# Adaptable Housing Report

3-5 Help Street

**Project:** Project Name & Address  
**Document Type:** Adaptable Housing Report  
**Our Reference:** P222\_481-3 (AS4299) DV

**Drawing No.**  
SSDA-4000

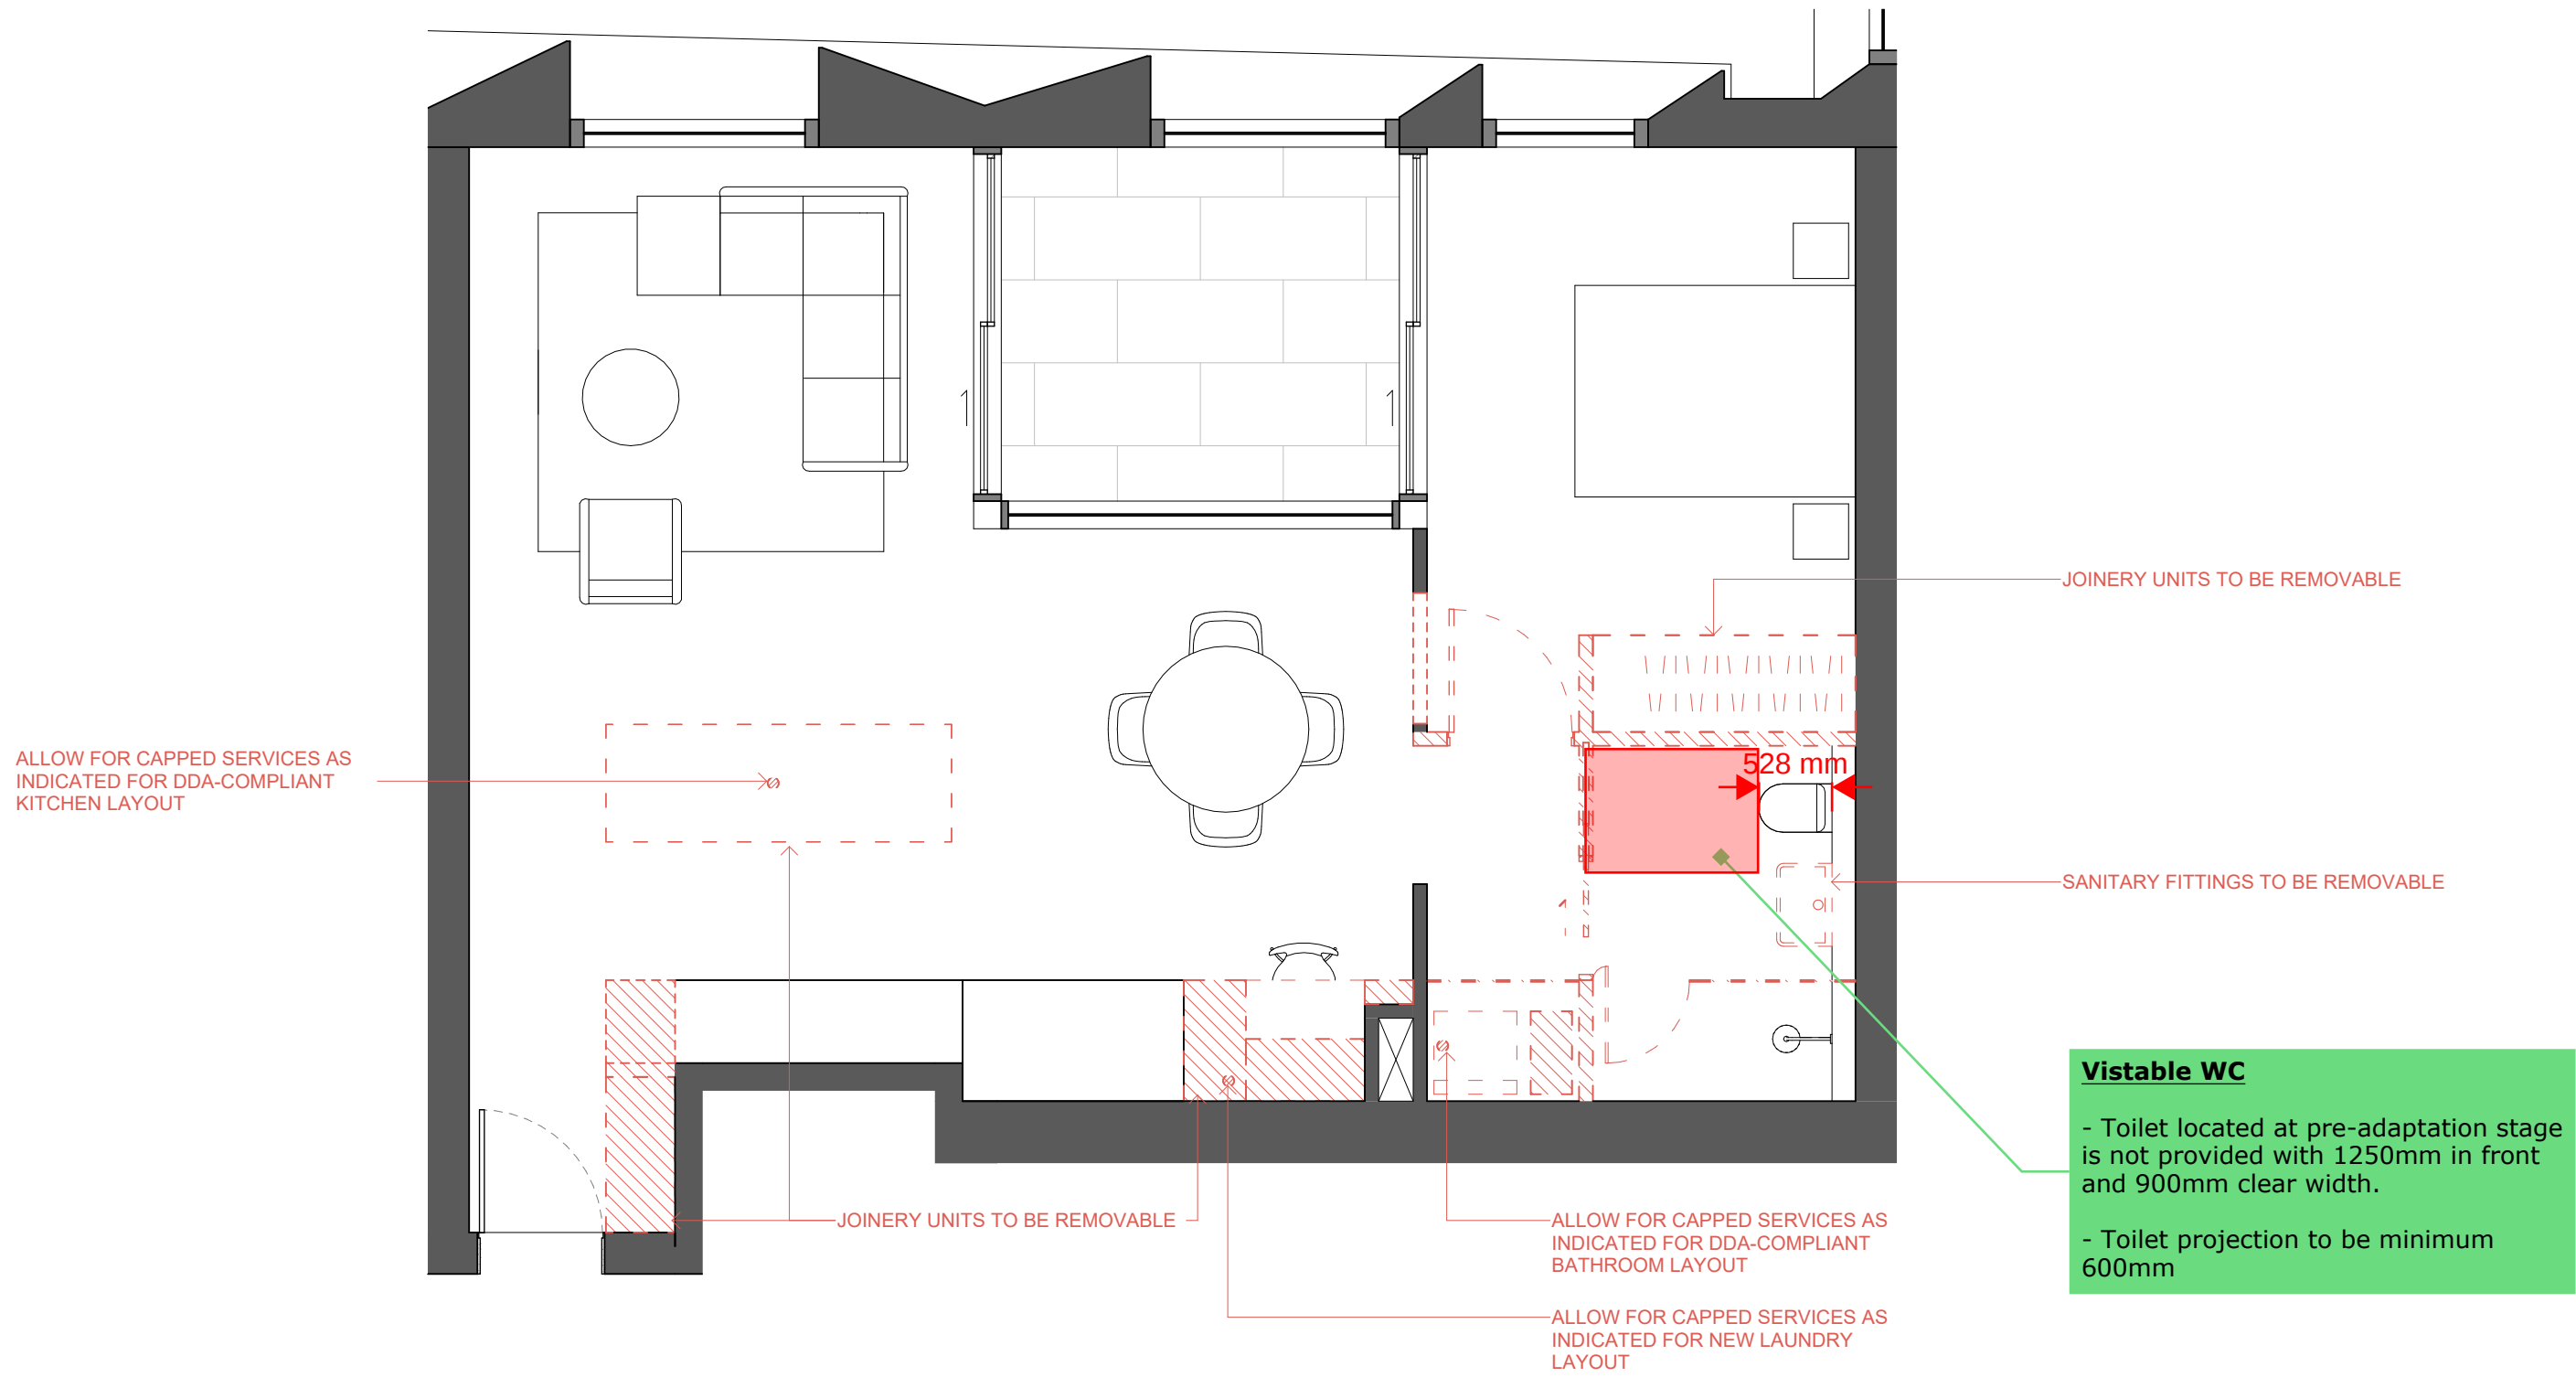
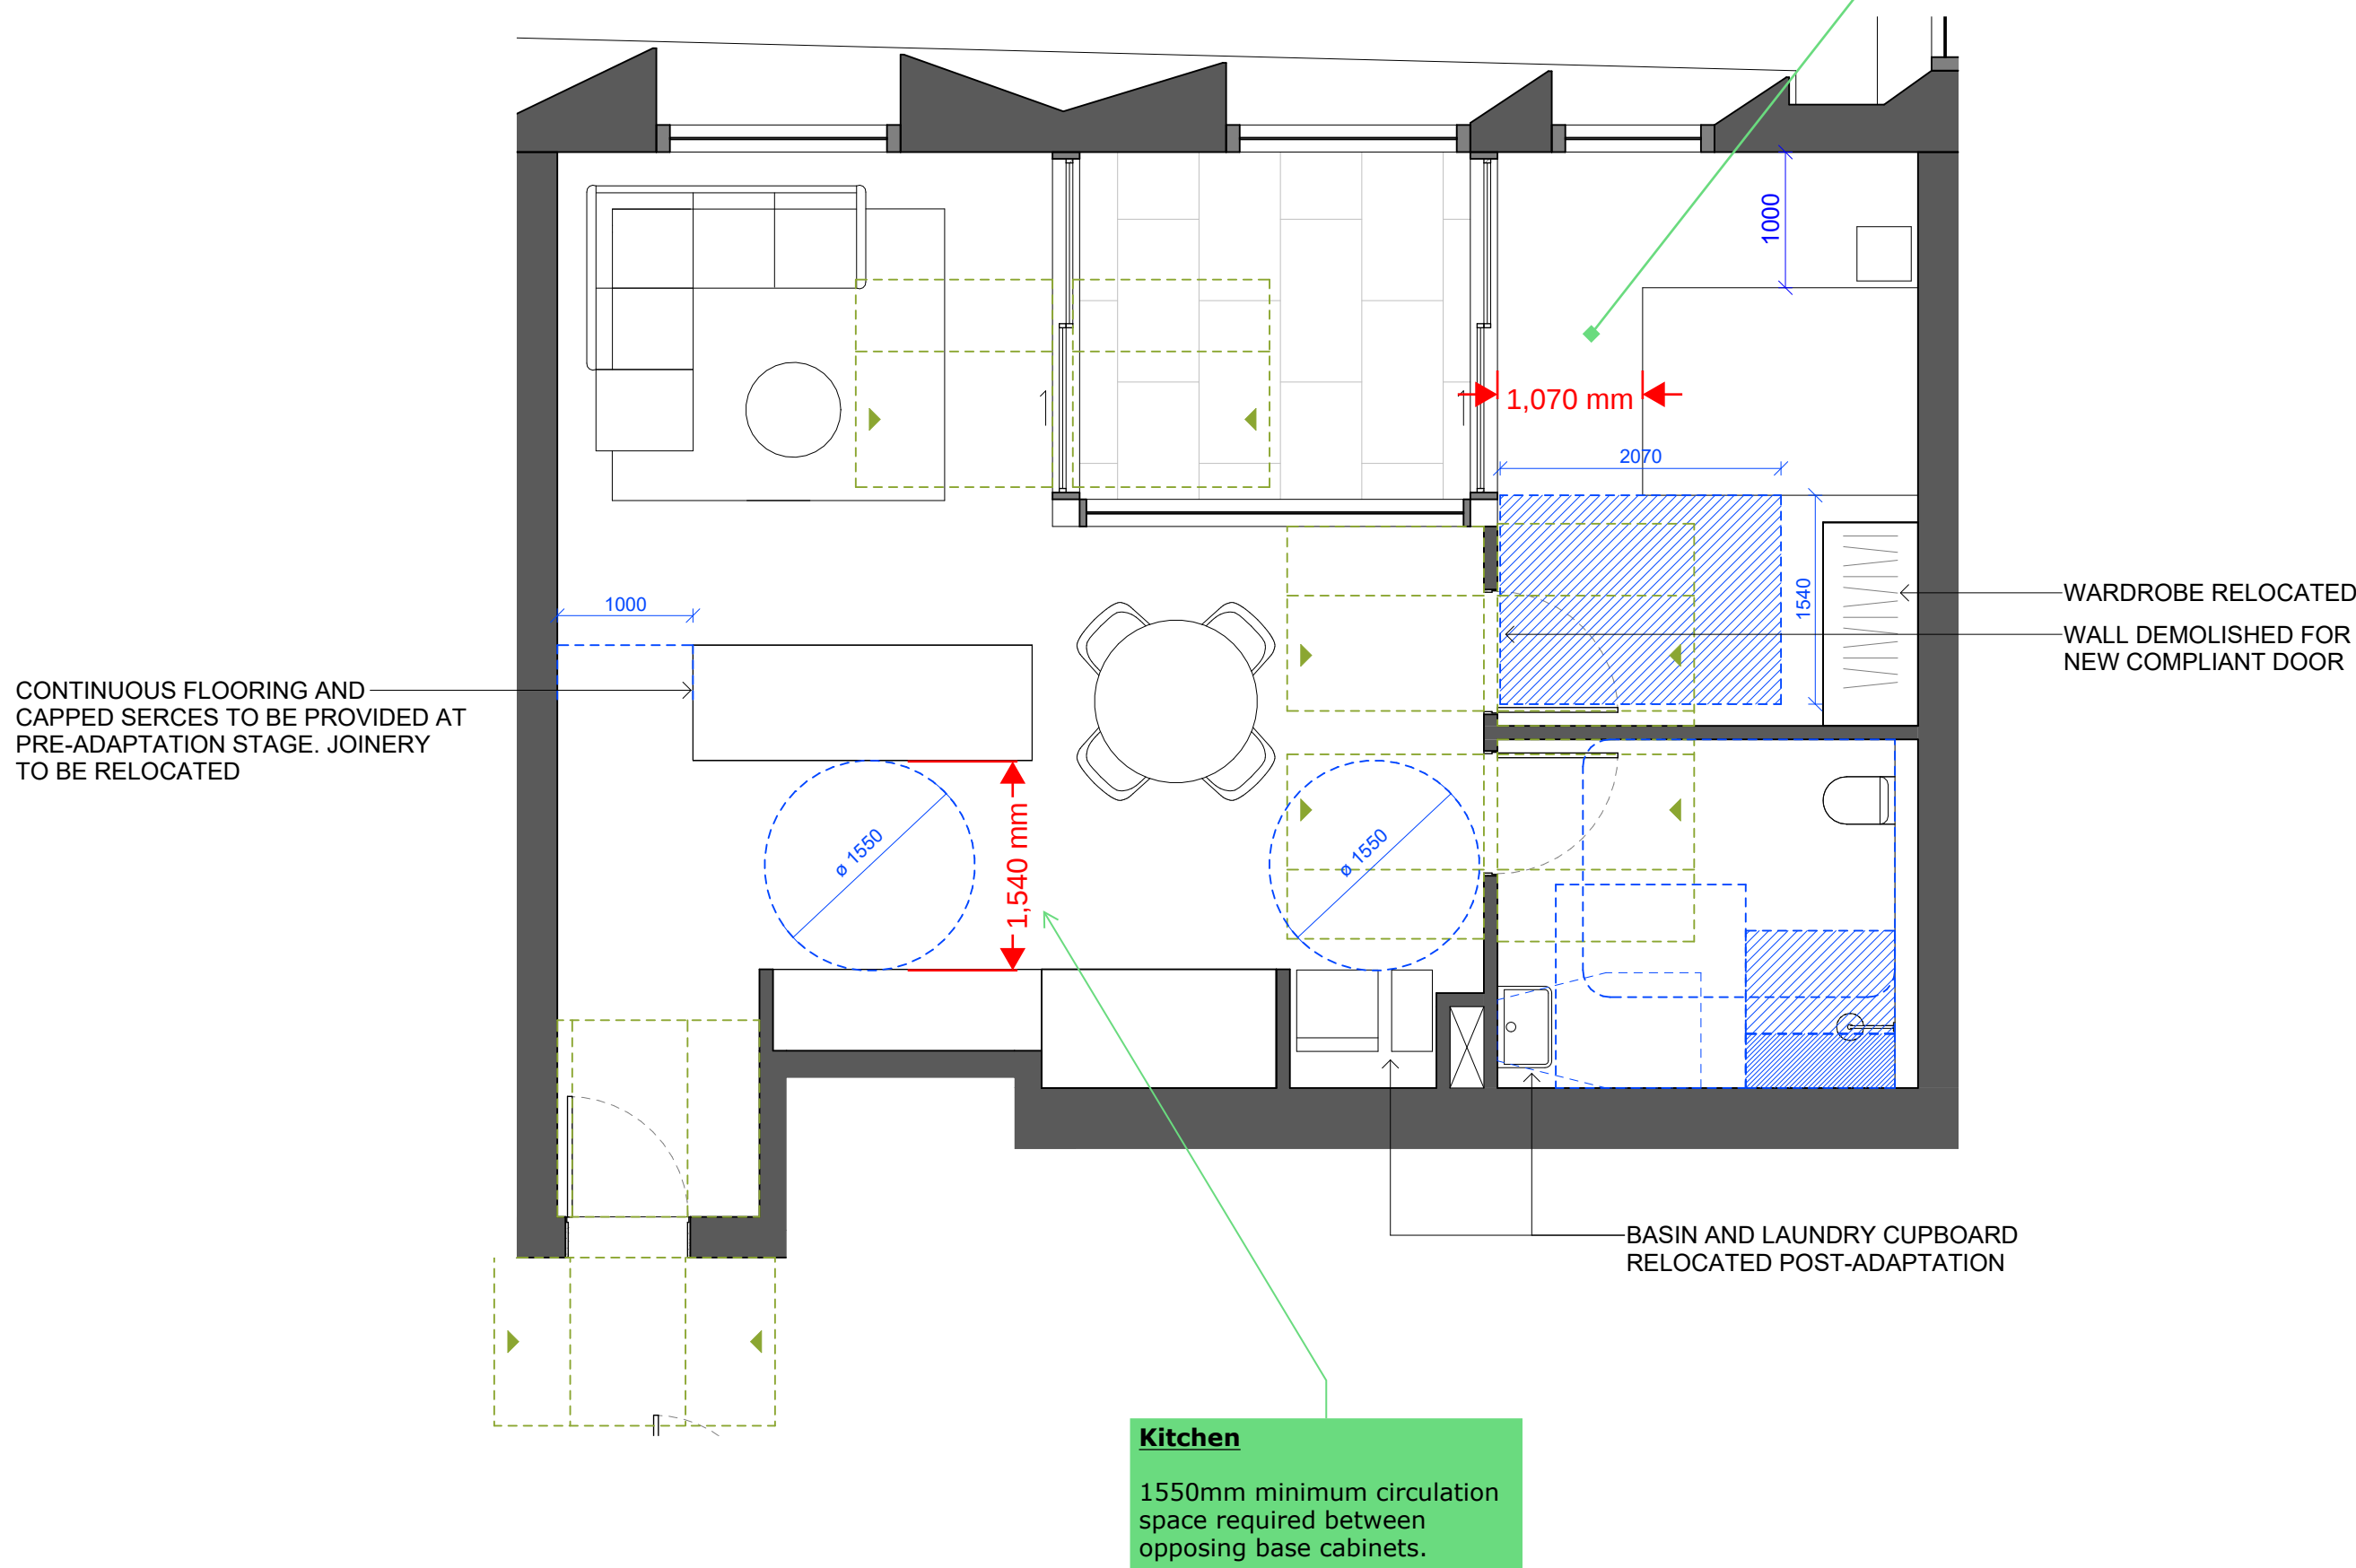
### Adaptable units

Sectional drawings to be provided for further assessment.

### Main Bedroom - Circulation Space

Less than 1200mm at the end of the bed.

DC Partnership can provide a performance based solution to a support the current design
